**World Forum for Harmonization of Vehicle Regulations****Working Party on Passive Safety****Seventy-fourth session**

**UN Regulation No. 14 (Anchorages of safety-belts)****Proposal for the 10 series of amendments to UN Regulation No. 14 (Anchorages of safety-belts) \*****Submitted by the expert from Finland**

Model A  
(see paragraph 4.4. of this Regulation)

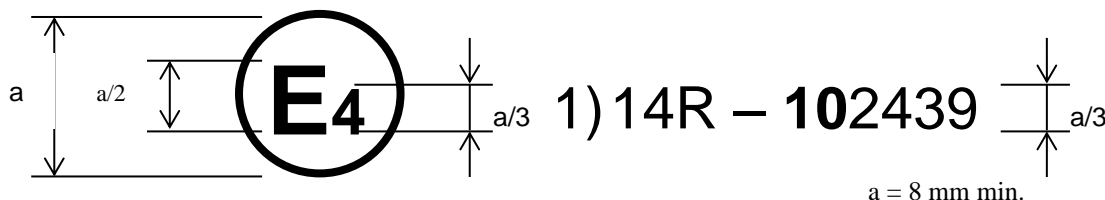
The above approval mark affixed to a vehicle shows that the vehicle type concerned has, with regard to safety-belt anchorages, been approved in the Netherlands (E 4), pursuant to UN Regulation No. 14, under the number 102439. The first two digits of the approval number indicate that UN Regulation No. 14 already included the 0910 series of amendments when the approval was given.

Model B  
(see paragraph 4.5. of this Regulation)

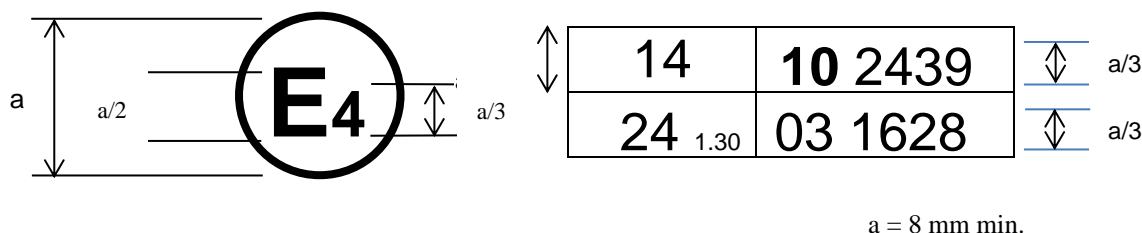
The above approval mark affixed to a vehicle shows that the vehicle type concerned has been approved in the Netherlands (E 4) pursuant to UN Regulations Nos. 14 and 24\*. (In the case of the latter Regulation the corrected absorption co-efficient is 1.30 m<sup>-1</sup>). The approval numbers indicate that on the dates on which these approvals were granted, UN Regulation No. 14 included the 0910 series of amendments and UN Regulation No. 24 was in its 03 series of amendments.
